E-Series	Model Description	Production Date
G90	M5 Sedan	SoP (@ 7/24)
G99	M5 Touring	SoP (@ 11/24)

During highly dynamic driving, washer fluid may be forced out of the windshield washer nozzles. This can lead to the washer fluid reservoir being completely emptied.

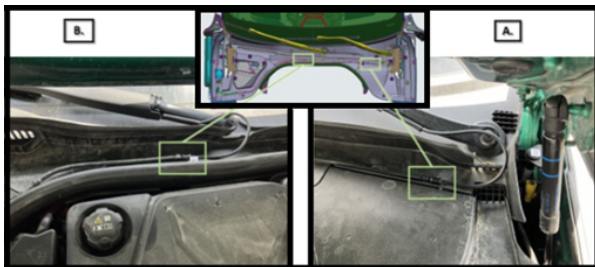
Insufficient fluid retention within the washer fluid supply hose system.

The driver and passenger side washer fluid diaphragms must be replaced with non-return (one-way) valves.
